DATE: December 10, 2018

SUBJECT: Addendum No. 1
Green Valley Road Slipout Repair Project, Contract No. 2776

GREEN VALLEY ROAD
 SLIPOUT REPAIR

SHEET
S-3
 7 OF 8
 W.G. No. **78707**

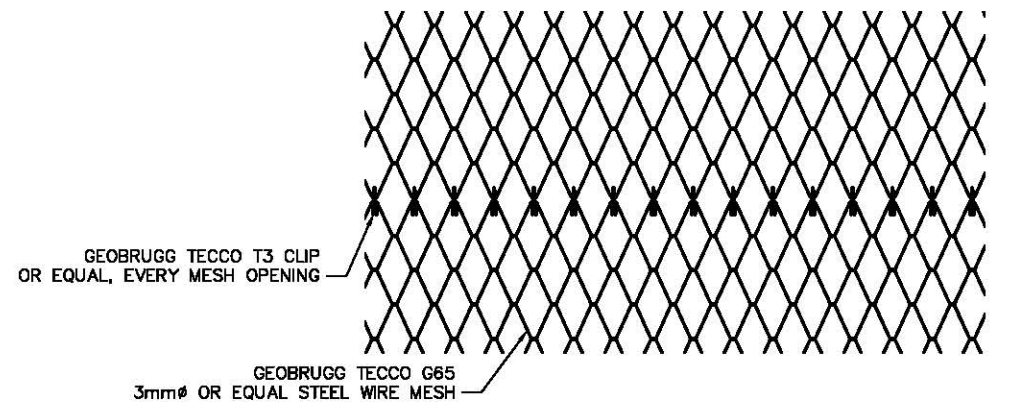
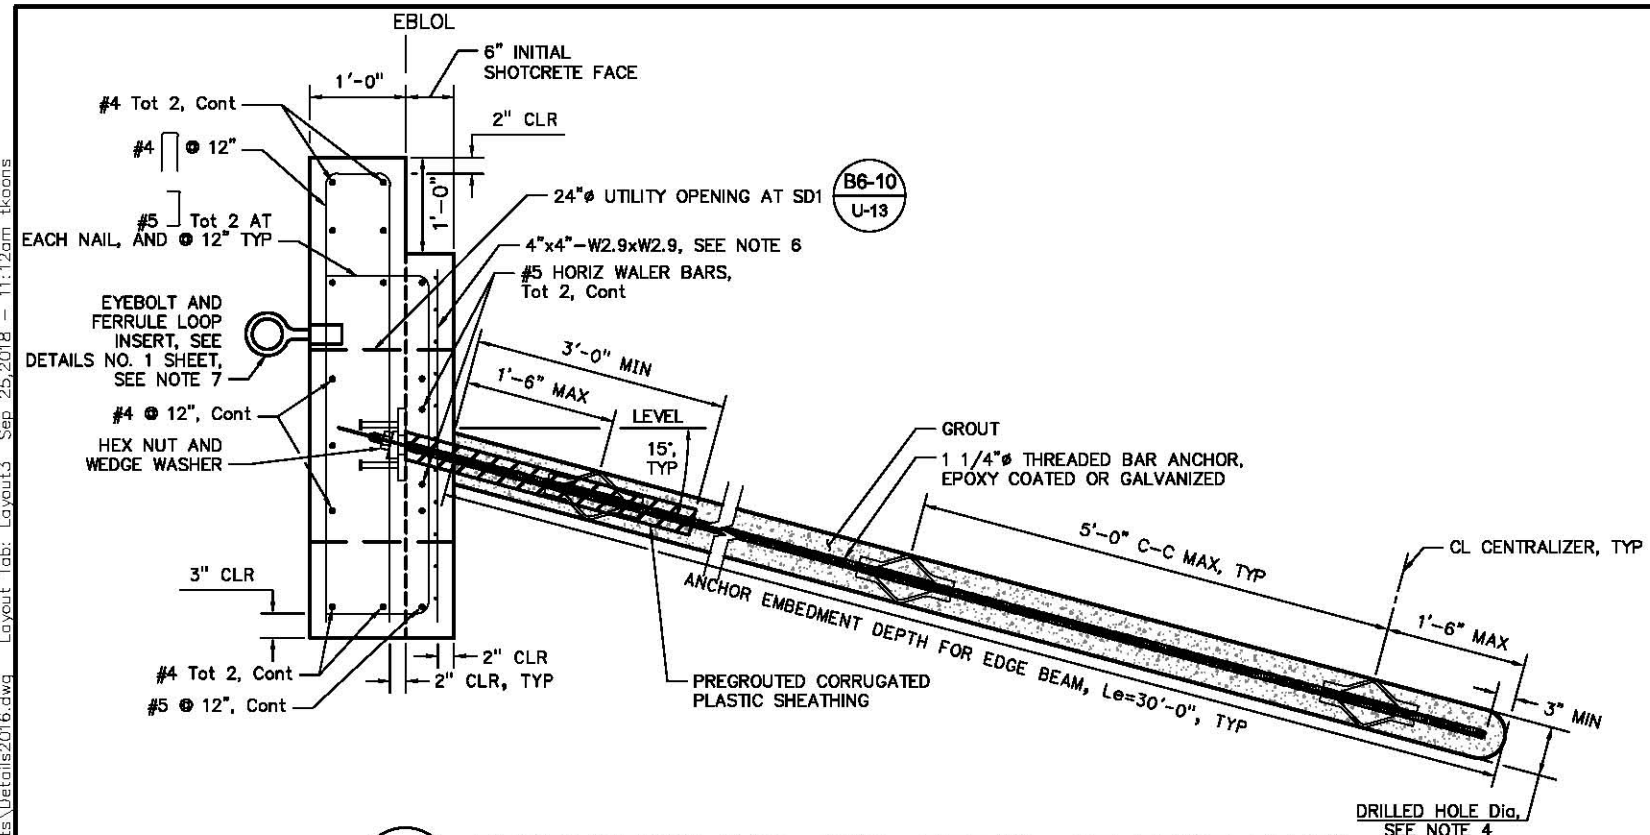
16. ALL MISCELLANEOUS MATERIALS INCLUDING WIRE ROPE CLIPS, THIMBLES, SHACKLES, SWAGED FERRULES, SHALL BE SUPPLIED BY THE VENDOR, AND GALVANIZED.
17. THREAD-BAR ANCHORS SHALL BE PERFORMANCE TESTED PER PROJECT SPECIFICATIONS. ~~A MINIMUM OF THREE (3) TOTAL THREADED BAR ANCHORS SHALL BE TESTED OR AT THE DISCRETION OF THE ENGINEER OF RECORD.~~
